17 June 2020

RE: Hobsons Road Catchment Flood Mapping Update

RE: Hobsons Road Catchment Flood Mapping – Response to Rain Consulting Model Review

Figure: 3	Rev: A	 Approx. Scale
---------------------	------------------	-----------------------

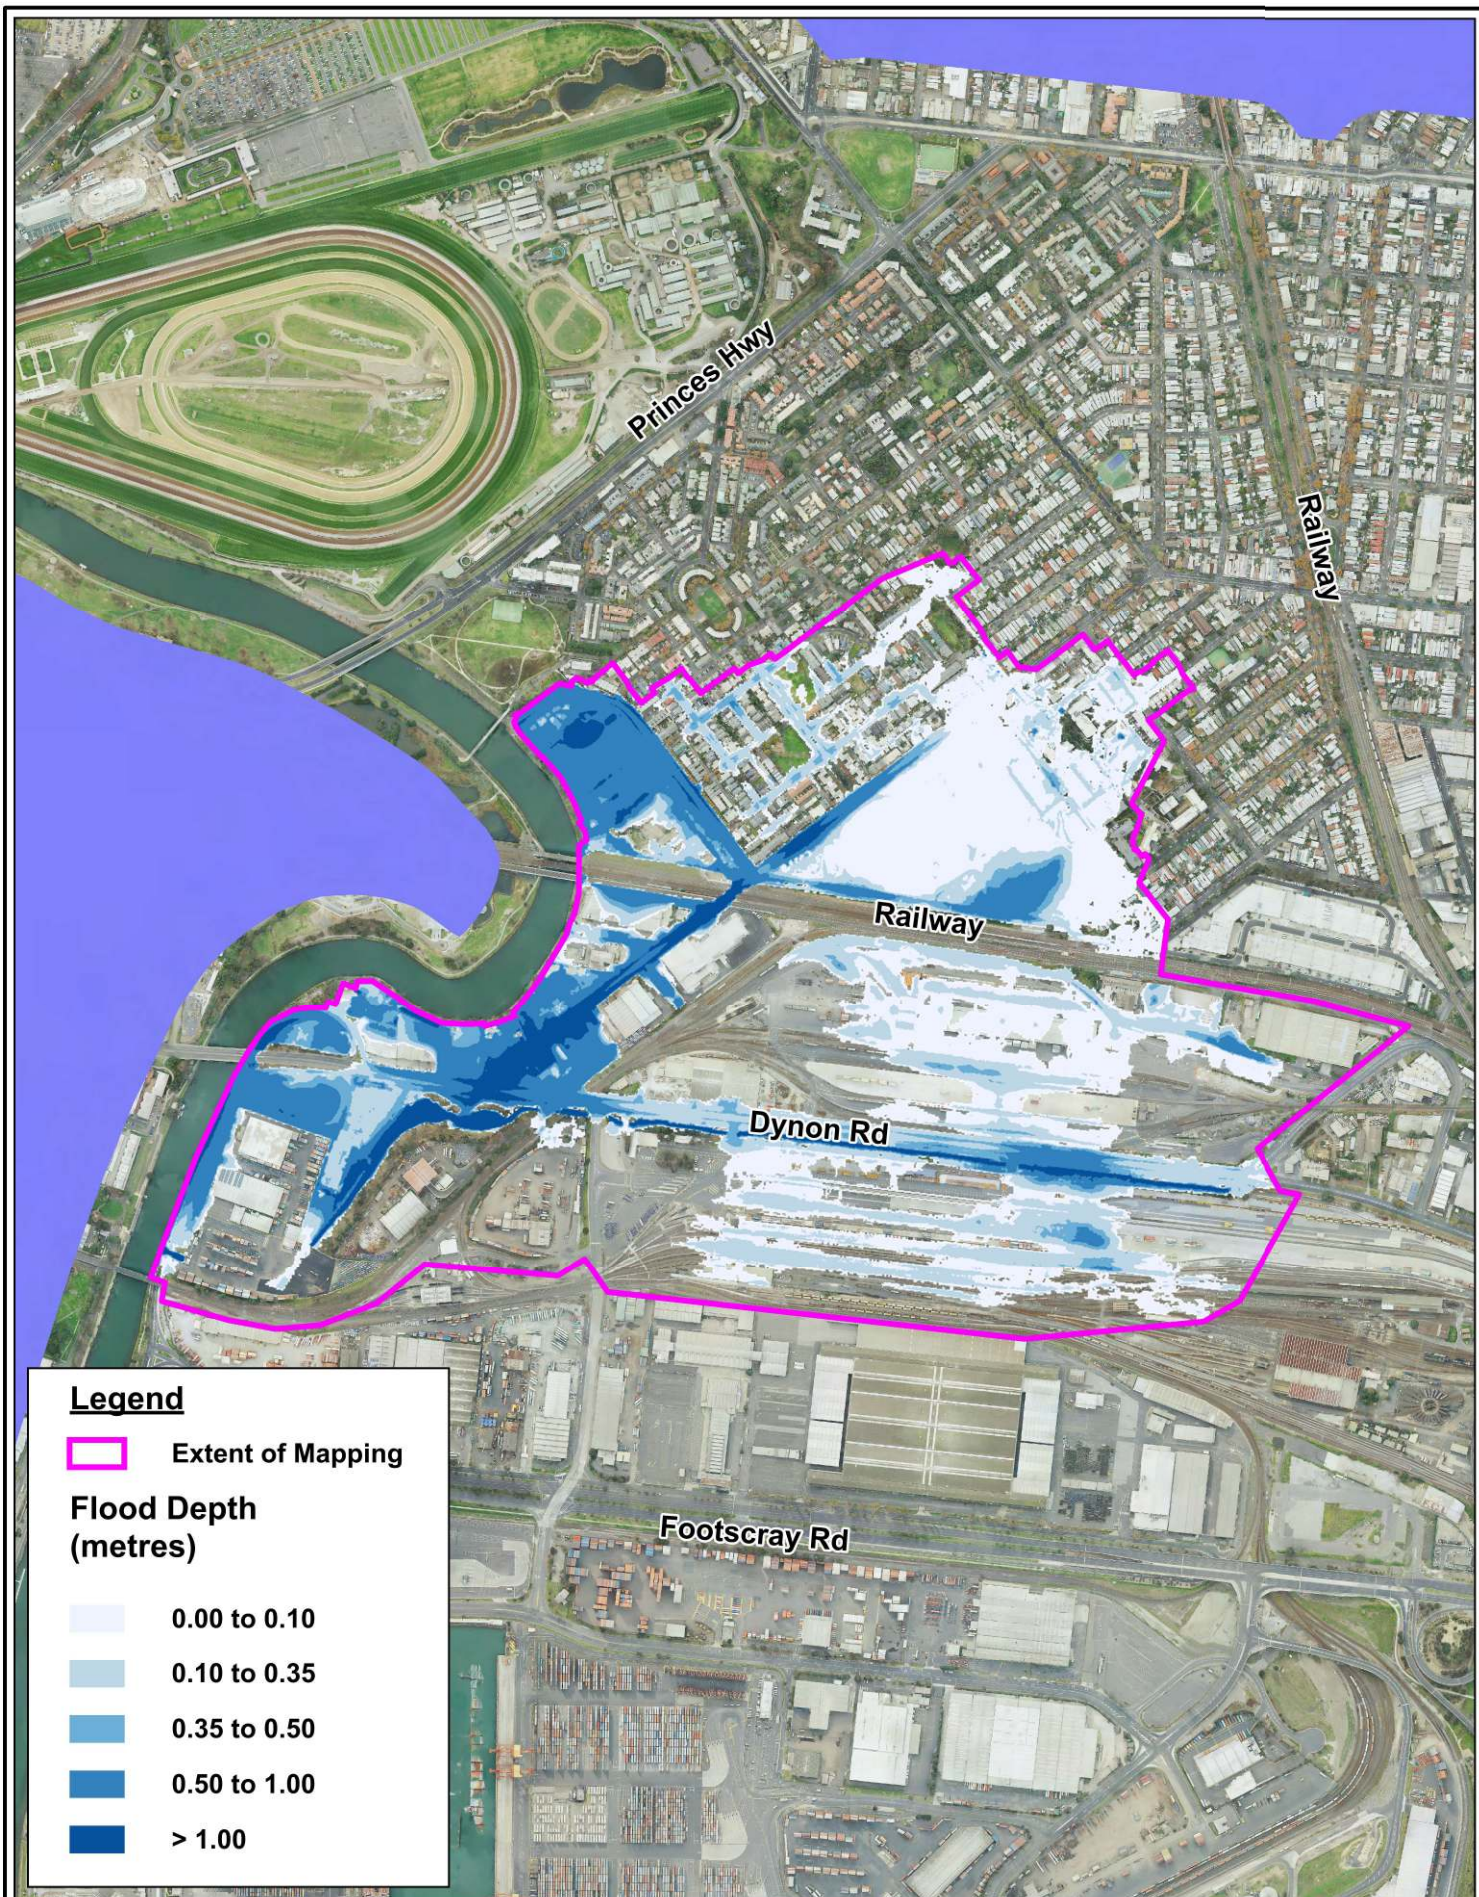
As shown in Figure 3 an outflow (downstream) boundary was placed on the pipe network at the intersection of Mercantile Parade and Flockhart St. At this location the pipe discharges into 2D domain but in an area outside the mapping extent for this model. The area between the mapping extent and the 2D model extent is generally in the next catchment to the north, but there is crossflow

from the Hobson Road catchment via the pipe network (see Figure 3) and overland flow. The supplied model applied a fixed level of 1.4 m AHD to this boundary which is approximately the pipe invert. This is a typical approach when a pipe outlets into a receiving waterbody and is not submerged. However, at this location the controlling level on the pipe flow at the peak of the flood will be the flood level in the street, assuming the pipe is surcharging. A sensitivity test was undertaken using a fixed level of 2.2 m AHD. This change was found to only increase flood levels locally by about 15 mm and was adopted for the final run in the model.
